ADDENDUM NO. 3

Dated: August 6, 2013

GREENWAY STORMWATER PARK

**DRAIN BASIN WITH
DOME GRATE DETAIL**

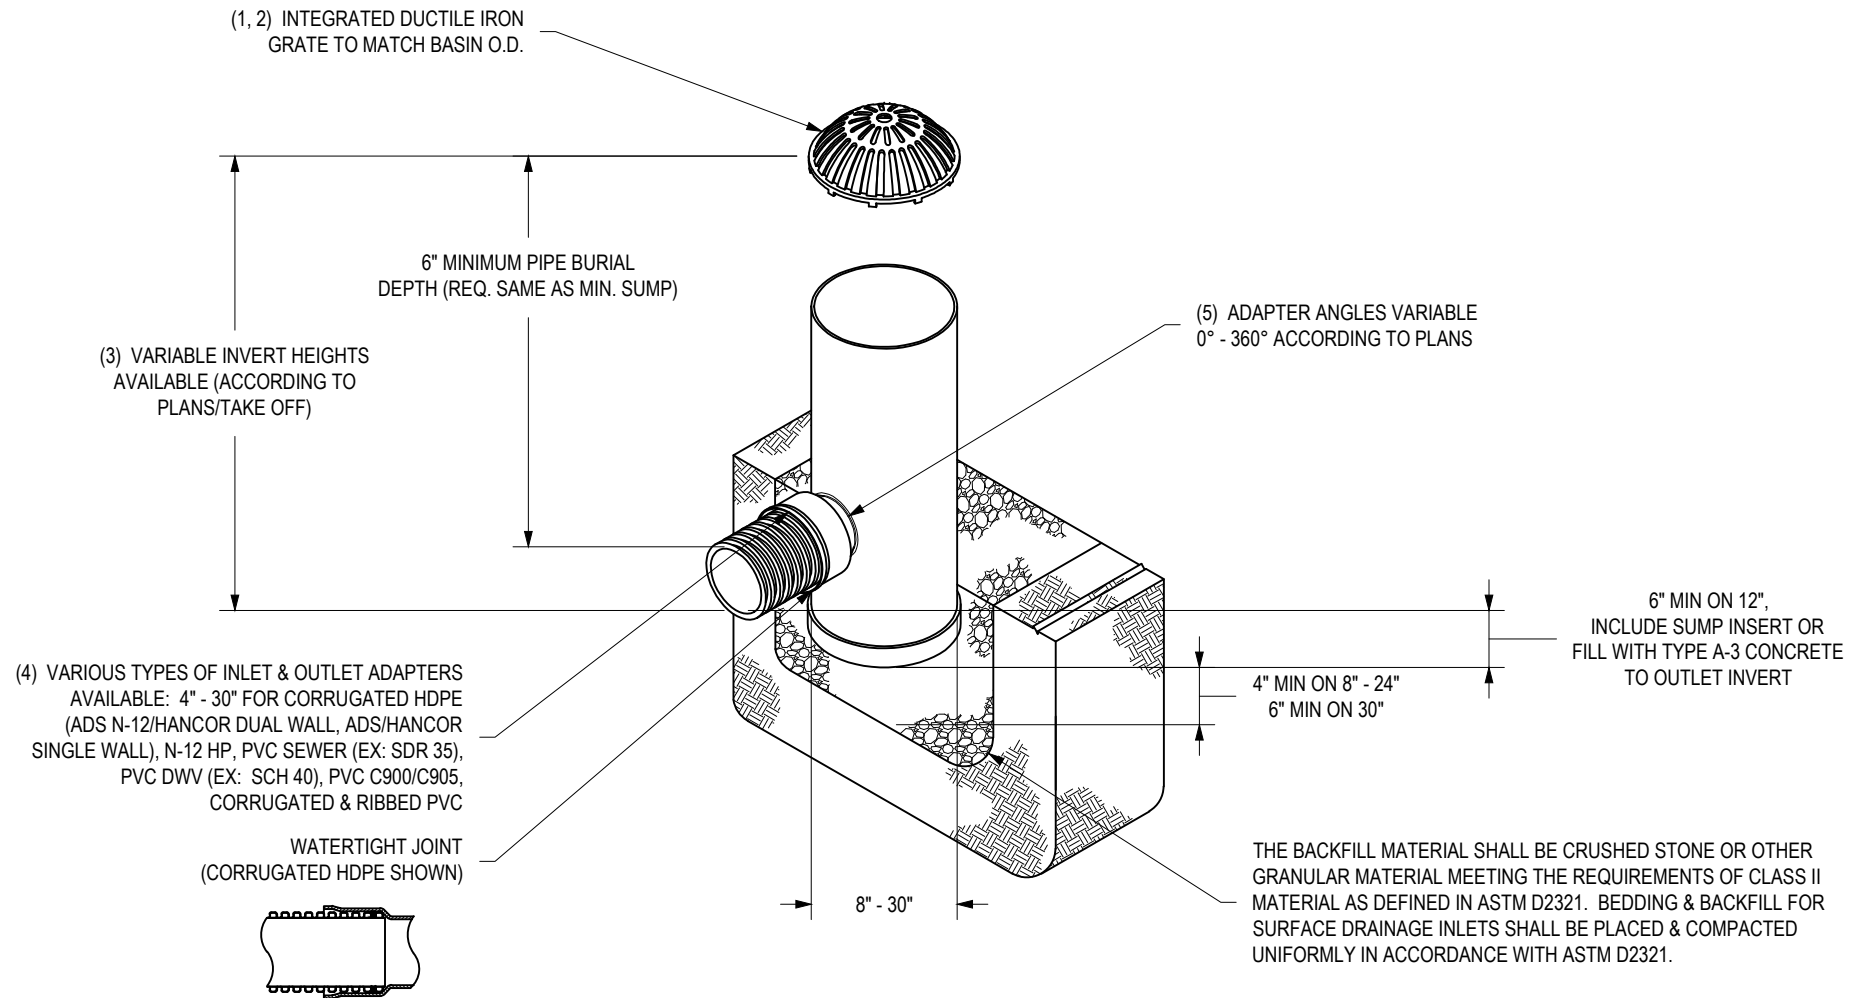
6. **Clarification:** Invert adjustments to drain basins and resulting elevation and length changes to the associated pipes will be handled as a field modification with the successful bidder. Please bid using quantities on Schedule of Unit Prices form.
7. **DRAWINGS; Sheet C603**

Replace: The SEWER AND DRAIN ELBOW/TEE W/CORR. PIPE AND ATRIUM GR. detail with the attached detail.

12" DRAIN BASIN WITH DOME GRATE

- 1 - 8" - 30" DOME GRATES SHALL BE DUCTILE IRON PER ASTM A536 GRADE 70-50-05.
- 2 - DRAIN BASIN TO BE CUSTOM MANUFACTURED ACCORDING TO PLAN DETAILS.
- 3 - DRAINAGE CONNECTION STUB JOINT TIGHTNESS SHALL CONFORM TO ASTM D3212 FOR CORRUGATED HDPE (ADS N-12/HANCOR DUAL WALL), N-12 HP, & PVC SEWER (4" - 24").
- 4 - ADAPTERS CAN BE MOUNTED ON ANY ANGLE 0° TO 360°.
- 5 - 8" - 30" DOME GRATES HAVE NO LOAD RATING.
